Groundwater Application Review Summary Form

Application # G- 18413

GW Reviewer Phil Marcy Date Review Completed: 4/13/2017

PUBLIC INTEREST REVIEW FOR GROUNDWATER APPLICATIONS

Water Availability Tables

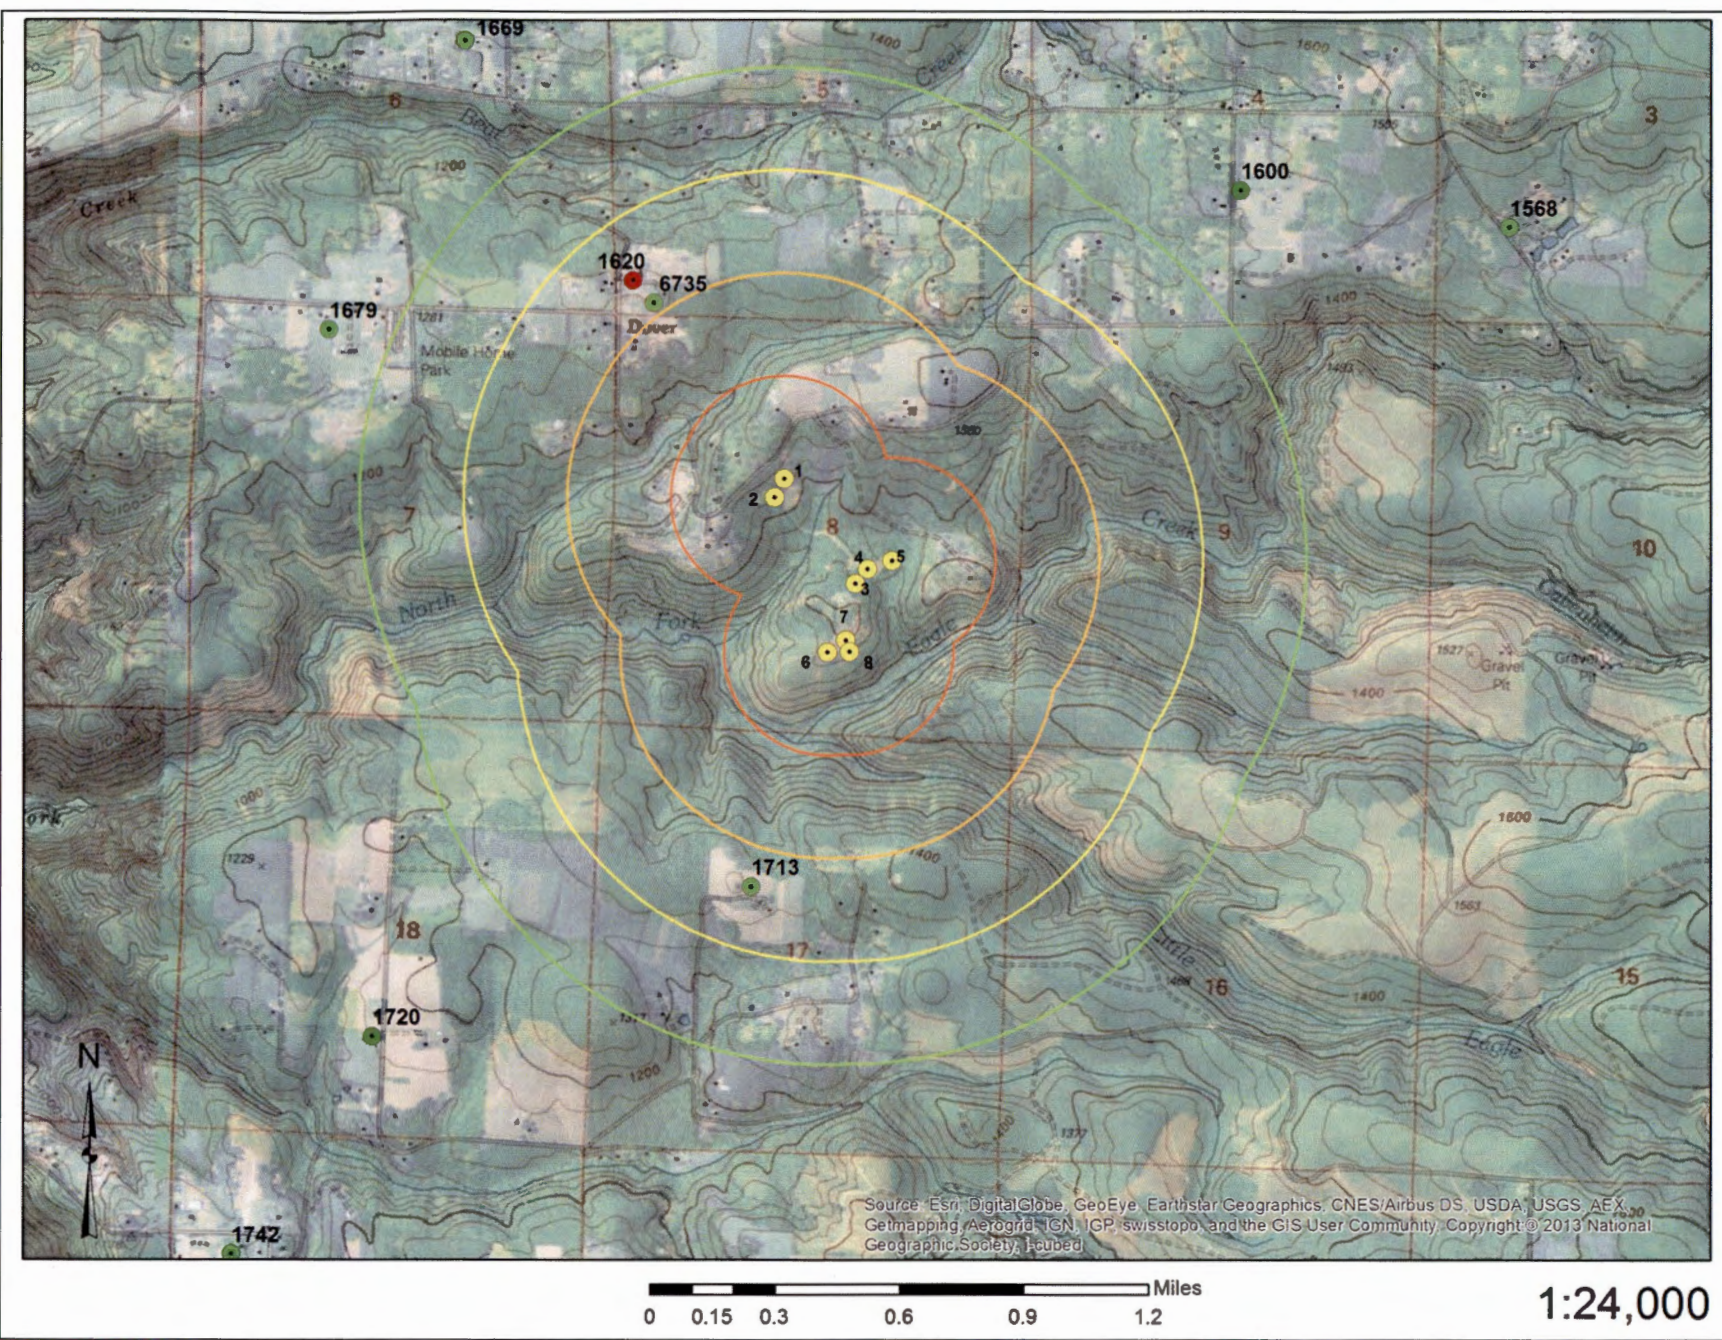
Water Availability Basin the well(s) are located within: North Fork Eagle Creek > Eagle Creek – At Mouth (ID# 138)
